## **INFORMATION LETTER**

**SUBJECT: MAIN TRANSMISSION SUPPORT CASE MOUNTS, NEW INSPECTION REQUIREMENTS.**

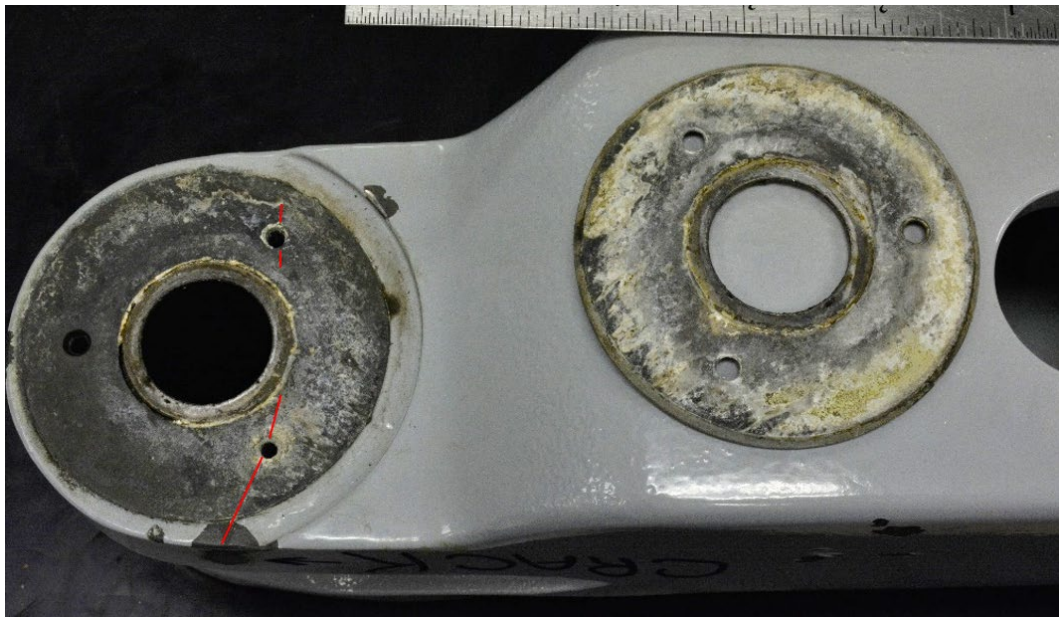
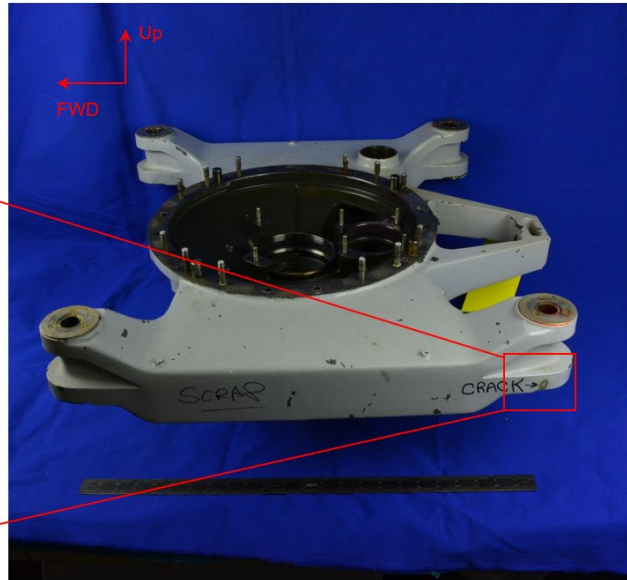
Bell occasionally receives reports of main transmission support cases found cracked at one of the lateral mounts. Cracking is usually caused by excessive corrosion of the surface under the washer and originates from a washer attachment screw threaded hole. Cracking can occur at the upper or lower surfaces of the lateral mount. The pictures on Page 2 show an example of a case found cracked during routine maintenance. To mitigate the risk of cracking due to corrosion, this Information Letter (IL) informs owners/operators of a new support case inspection requirement that has been incorporated in the Maintenance Manual (MM).

At the interval specified by the latest manual revision, the washers installed on the upper and lower surfaces of the support case lateral mounts must be removed to inspect the area in accordance with the latest criteria. The Component Repair & Overhaul Manual (CR&O) has also been revised to include washer removal and installation instructions as well as corrosion damage limits for the affected area.
